780-001-11

ADDENDUM NO. 1

Freeman Public Schools
 Adams, Nebraska
 TCEP No.: 780-001-11

Addendum #01
Supplemental Drawing: SDM-004
Revision of Sheet: M2.00
Date: 09/26/12

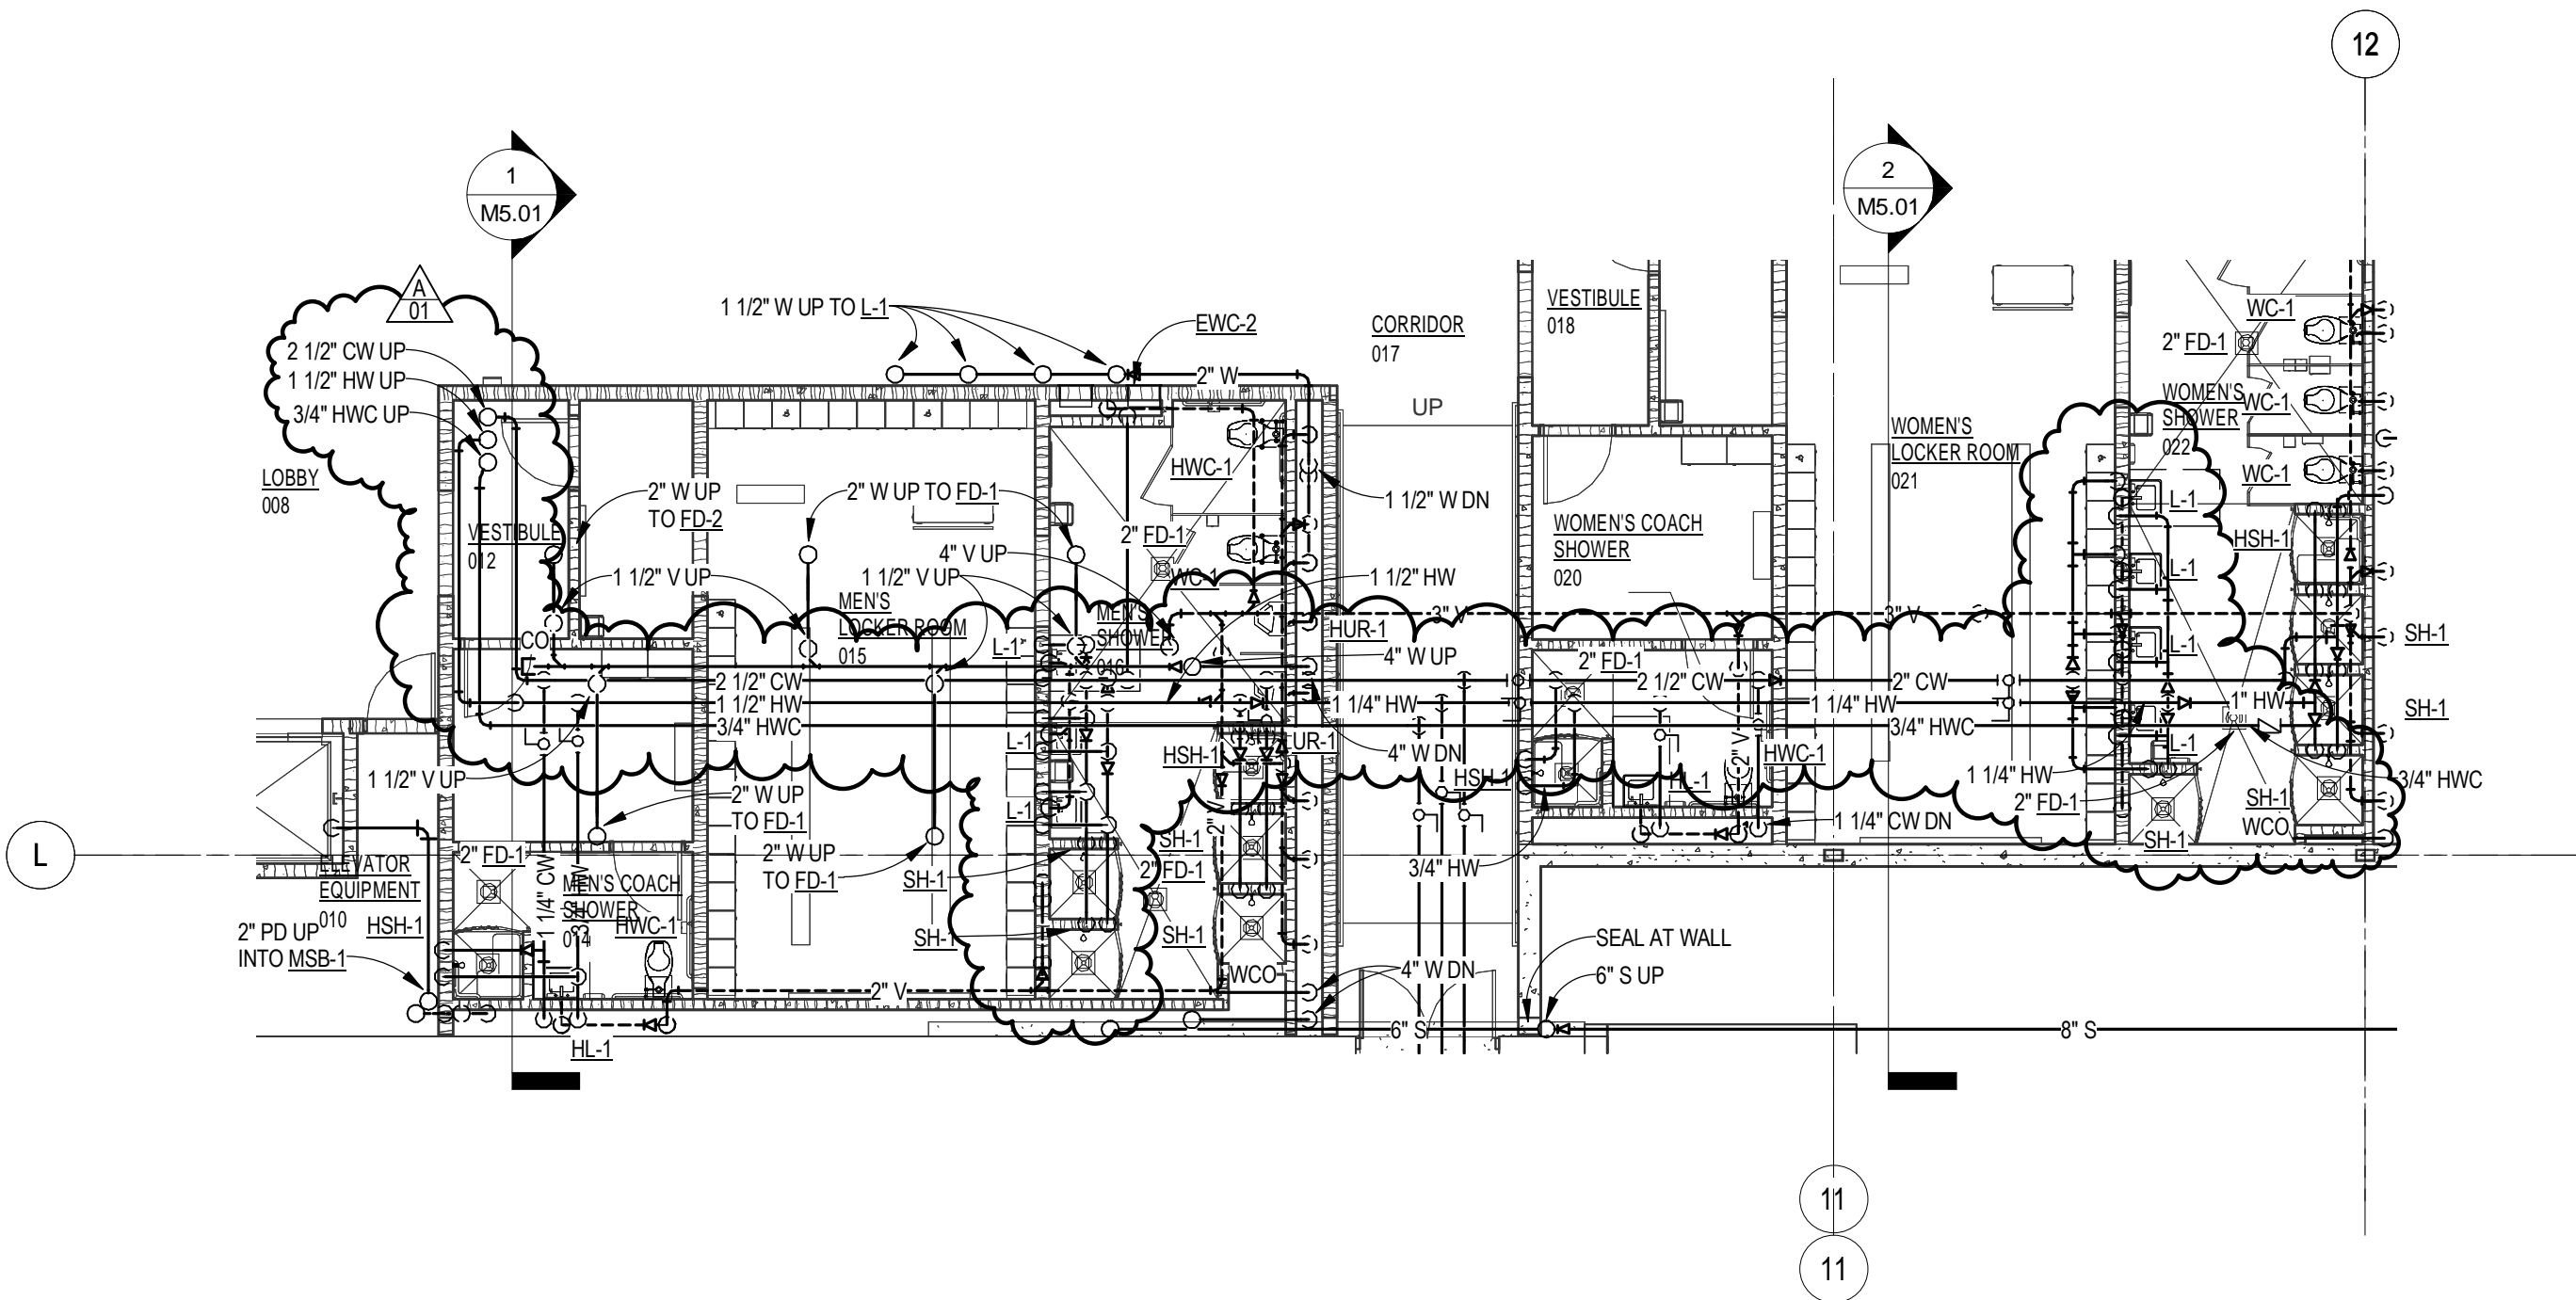
Refer to attached supplemental drawing SDM-004 for revised piping for additional showers.

BASEMENT PIPING PLAN

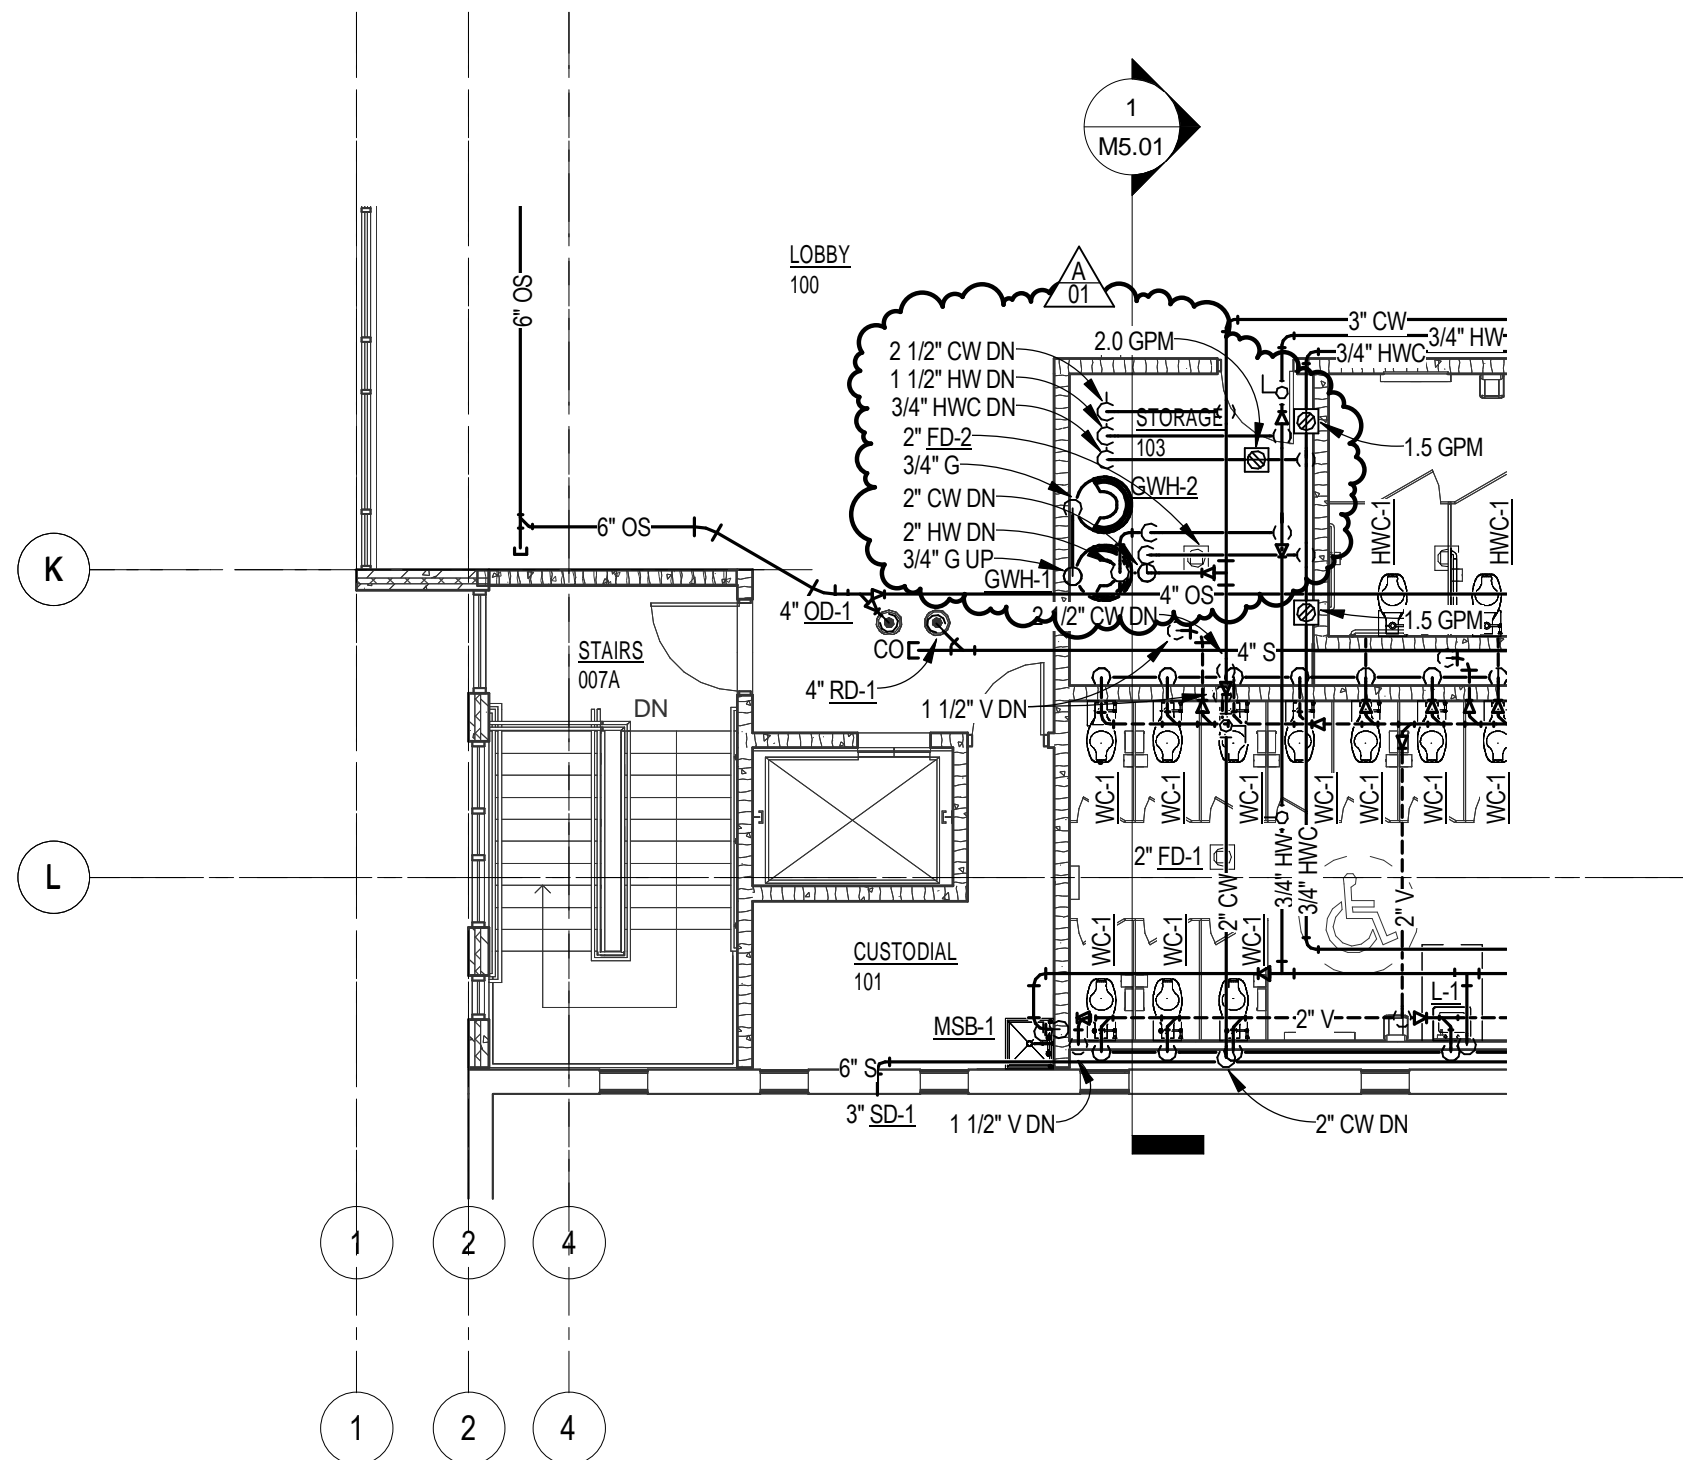
Refer to attached supplemental drawing SDM-005 for revised piping for additional showers and pipe size changes.

Addendum #01
Supplemental Drawing: SDM-006
Revision of Sheet: M2.02
Date: 09/26/12

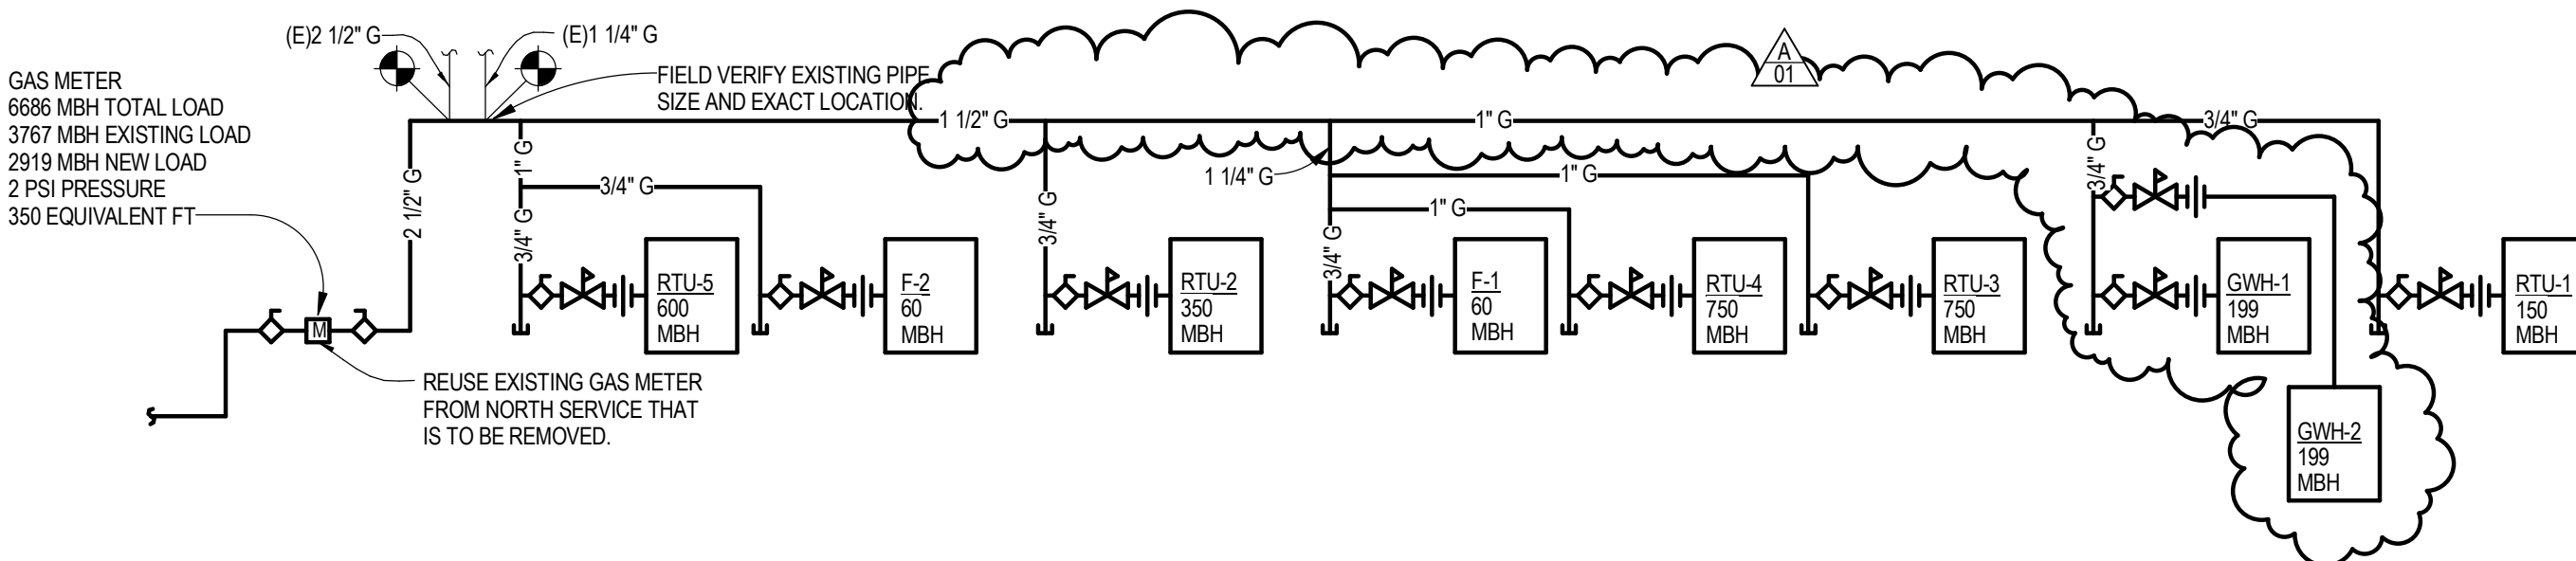
Refer to attached supplemental drawing SDM-006 for revised piping and sizes for additional water heater.

Addendum #01
Supplemental Drawing: SDM-007
Revision of Sheet: M4.01
Date: 09/26/12

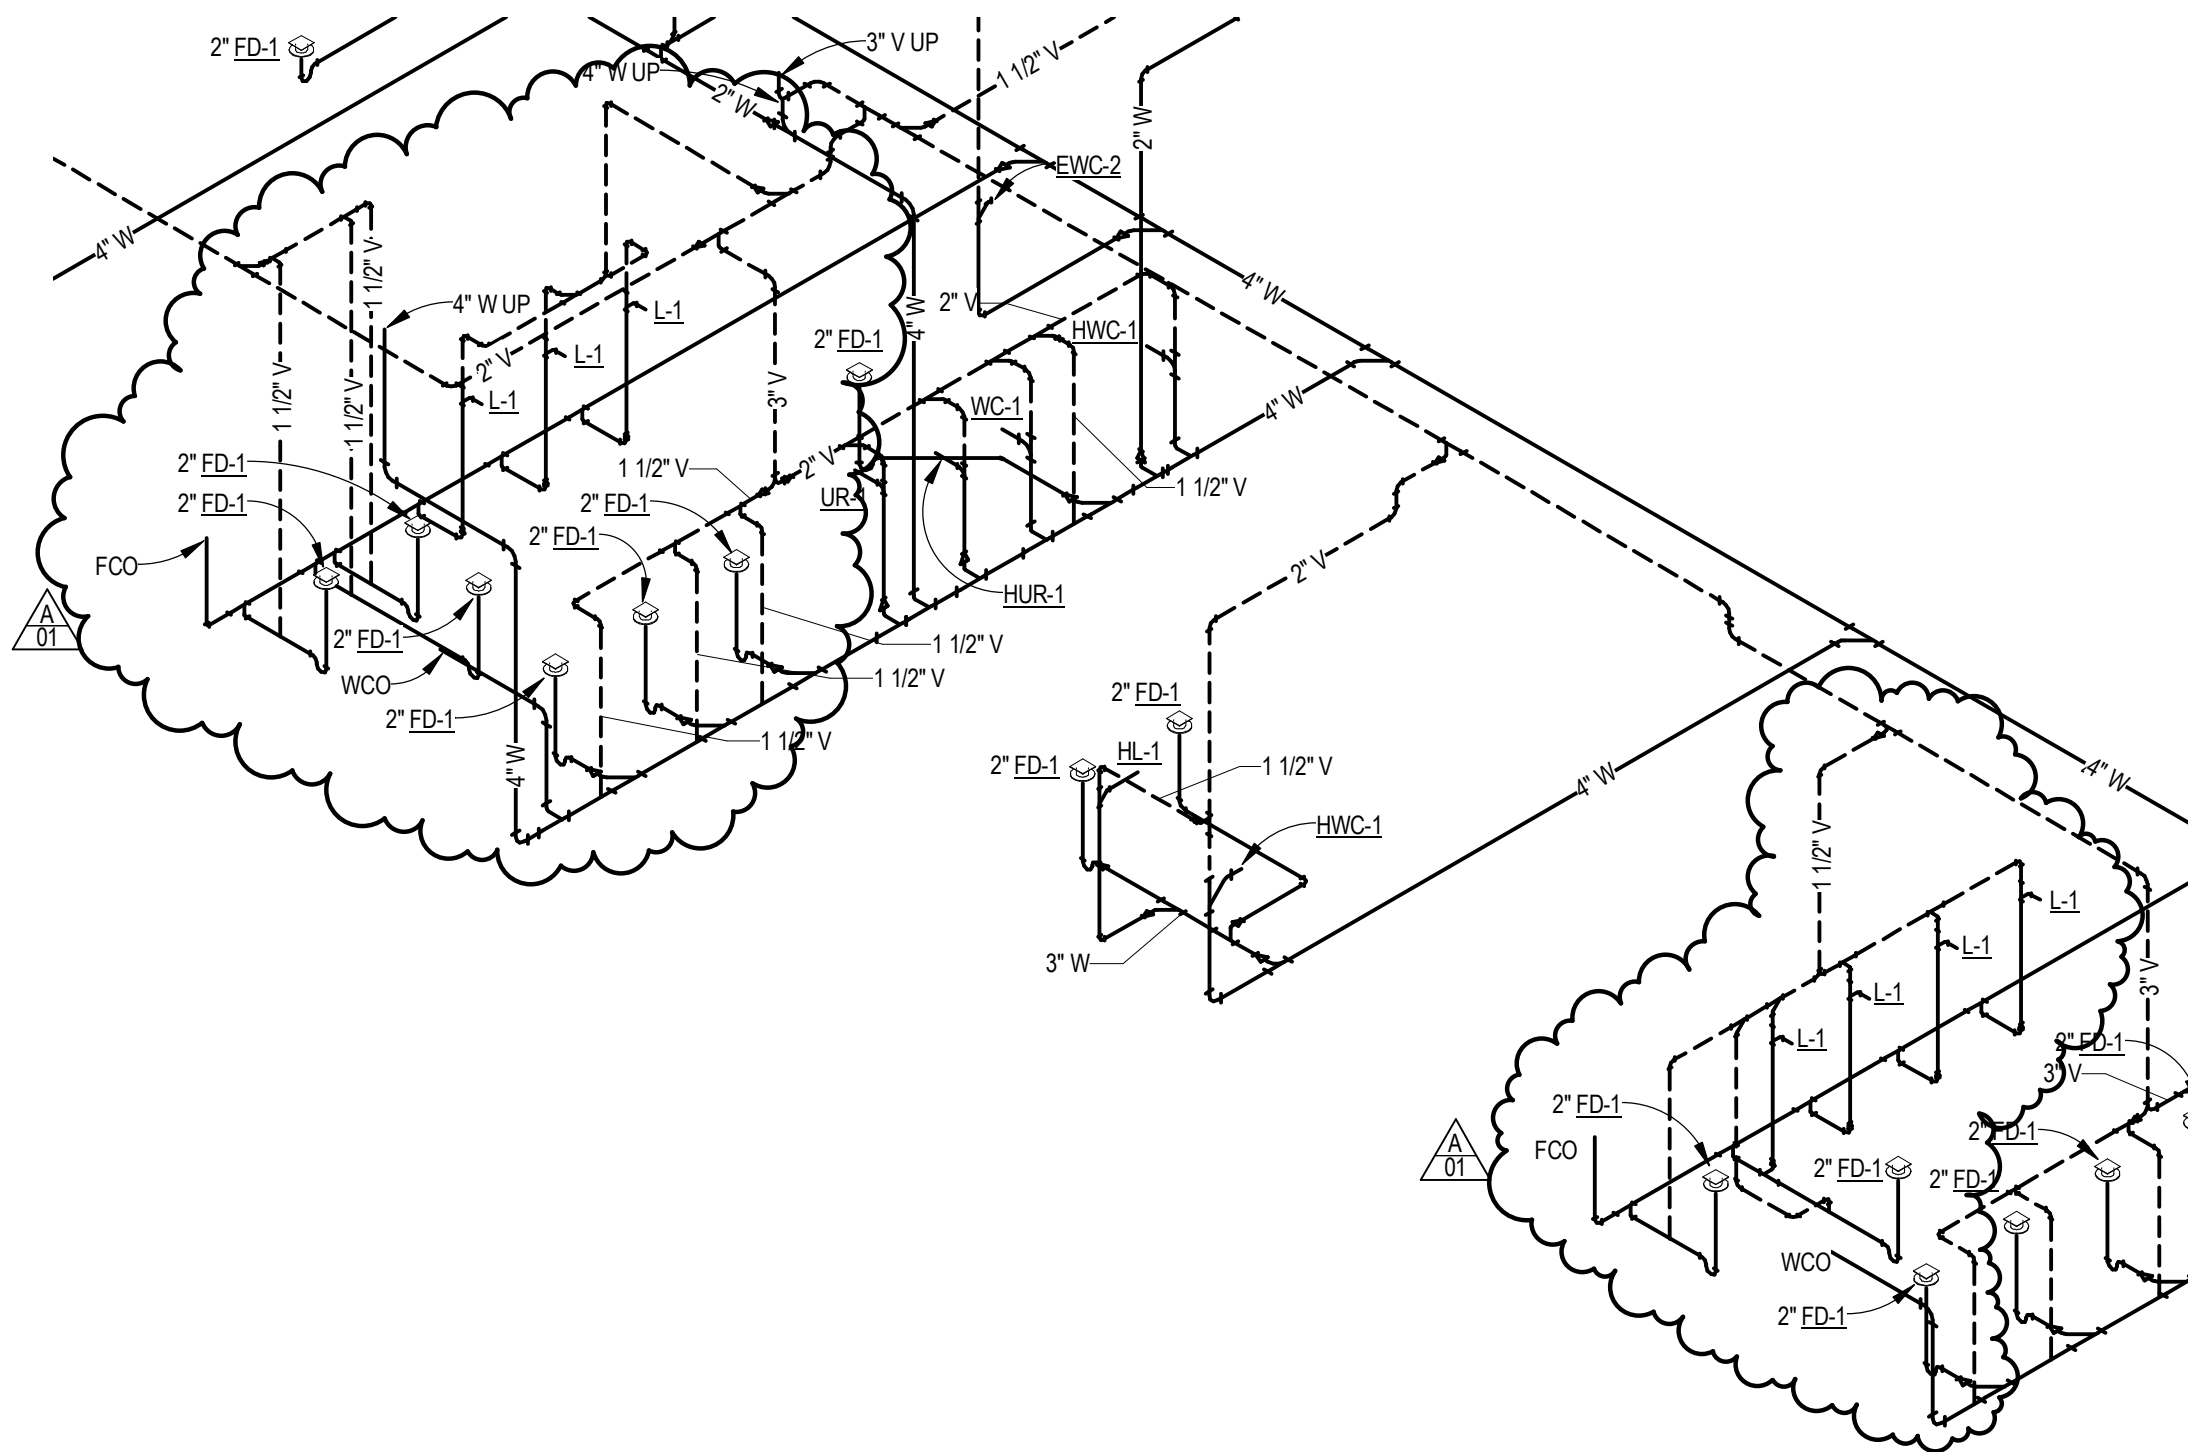
Refer to attached supplemental drawing SDM-007 for revised gas piping sizes for additional water heater.
